City of Fenton  
 Old Highway 141 Bridge Value Engineering Proposal  
 Final VE Quantities  
 3/29/2011

**OLD HIGHWAY 141  
ROADWAY IMPROVEMENT PLANS**  
FENTON, MISSOURI  
Prepared For:  
**CITY OF FENTON**

**Re: Value Engineering of Fenton Creek Bridge Replacement  
Project No. BRM-4989(606), Bridge No. 1420013  
Response to Review Comments and Revised Final Plans**

PART PLAN SHOWING REINFORCEMENT

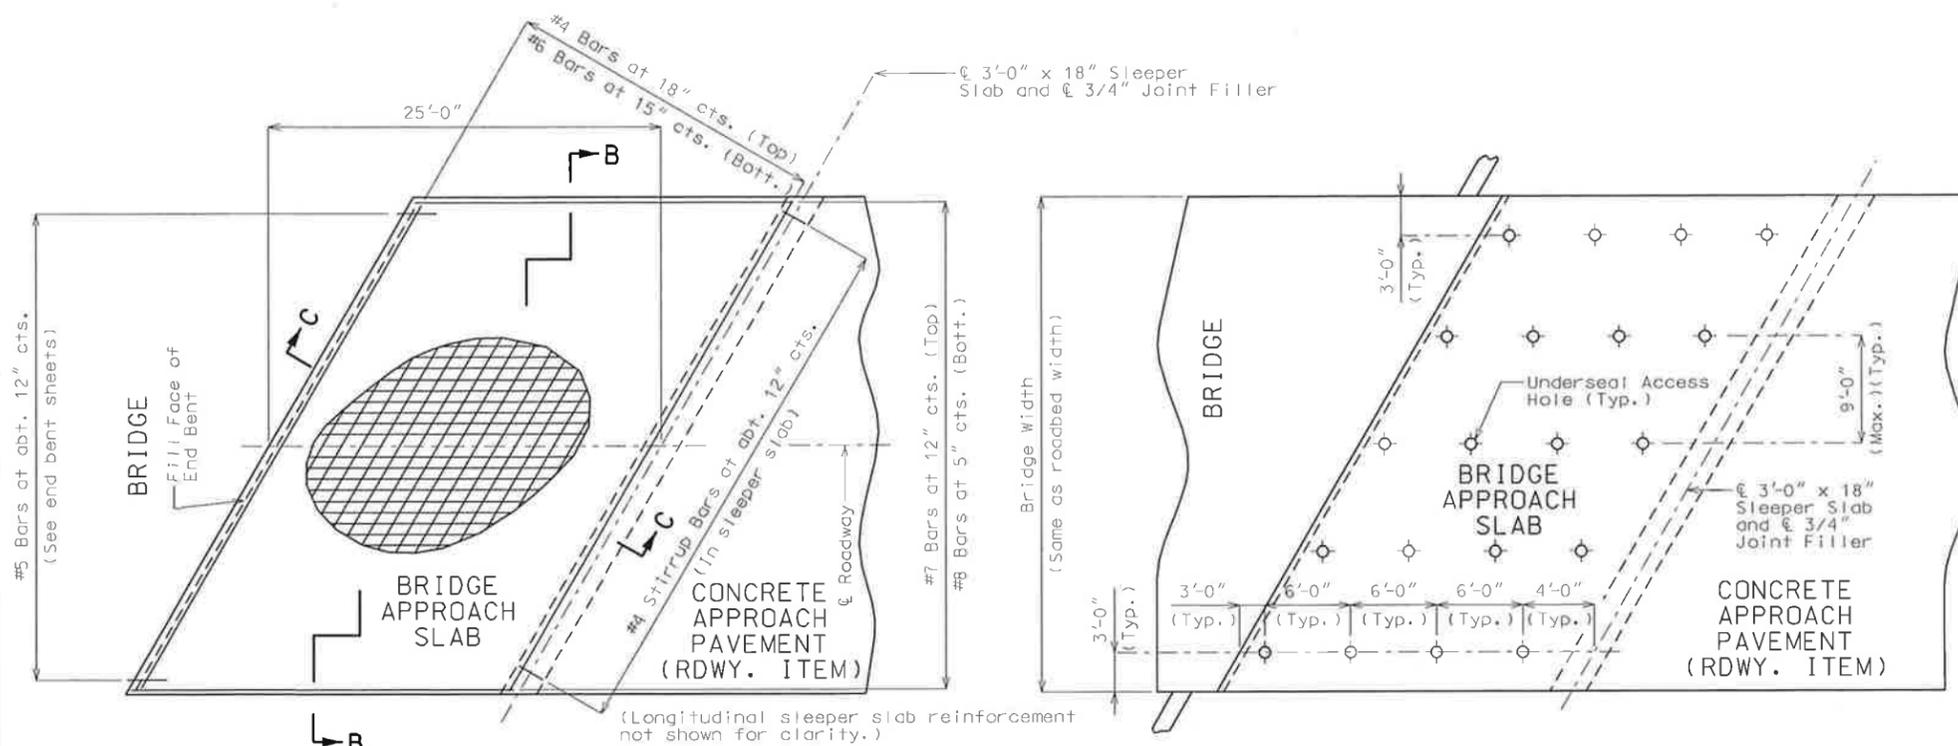
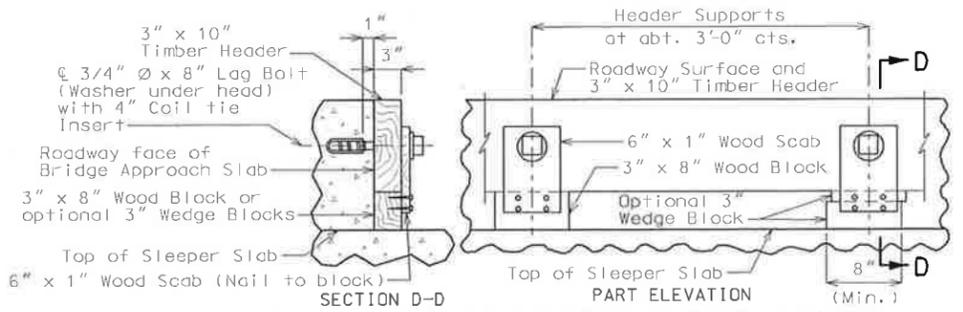
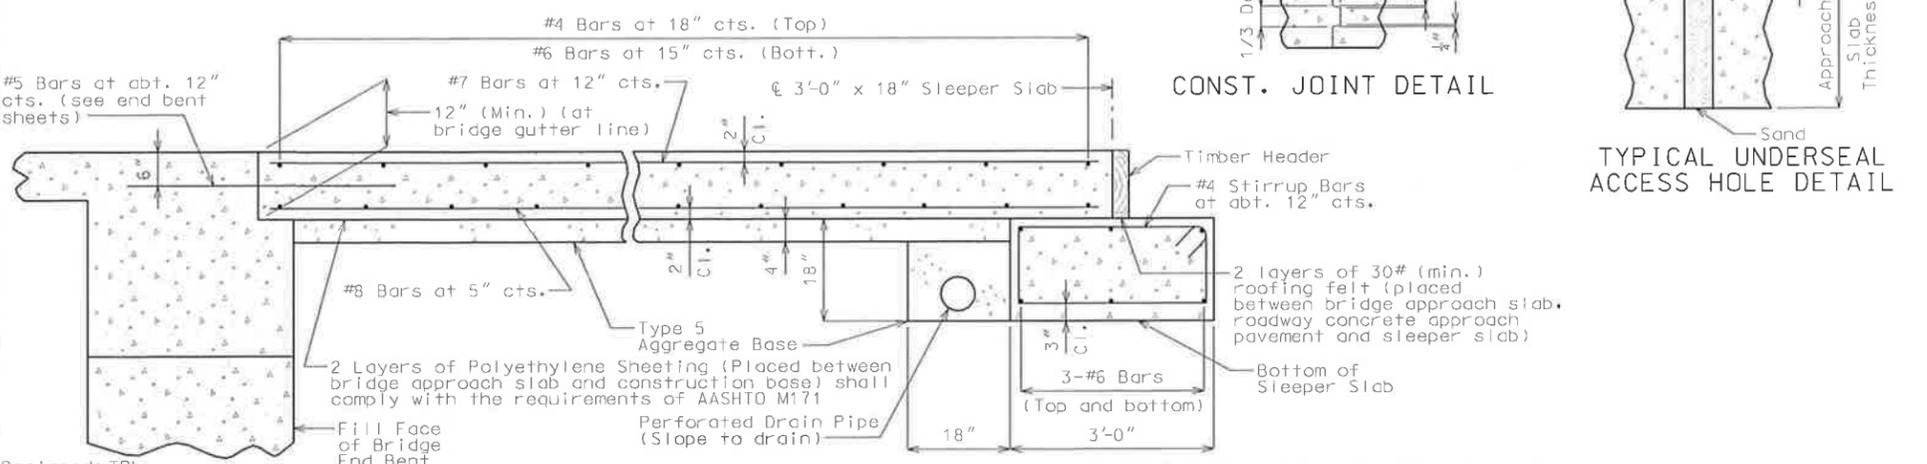
31. PART PLAN SHOWING REINFORCEMENT, PART PLAN and SECTION B-B show and/or callout Type A curb at the edges of the approach slabs. Remove all references and depictions of Type A curb. No curb will be provided. **This sheet was modified and completely replaced to remove the Type A curb.**
32. Remove section cut for Section E-E shown on PART PLAN SHOWING REINFORCEMENT. **Section was removed.**
